Figure 1 – Order of hardware assembly on fiberglass brackets with a star washer option

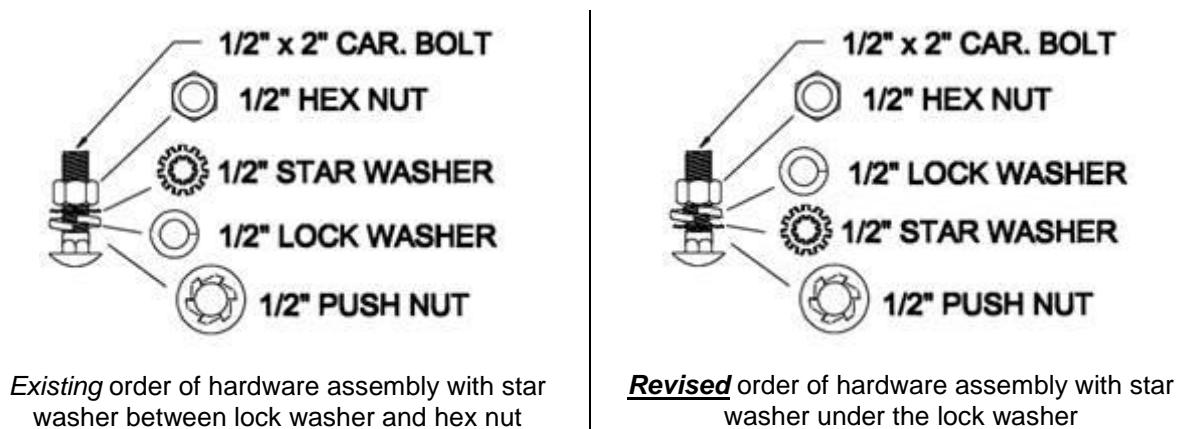
The the order of hardware assembly on Fiberglass Brackets with a star washer option (Catalog numbers ending in “W” or “WC”) are having the order of the associated hardware revised so that the star washer sits against the end fitting of the bracket as opposed to between the lock washer and hex nut. See the Figure 1 for a visual diagram of the change.

This change makes it easier for end users to assemble the bracket in the field without having to reconfigure the order of the hardware when attaching equipment to the bracket and reduces the chance of operator miss-installation.

This change has been implemented as of December 1, 2019 and there are no changes required to existing catalog numbers. Please contact your MacLean Power Systems Sales representative with any further questions or for additional assistance.
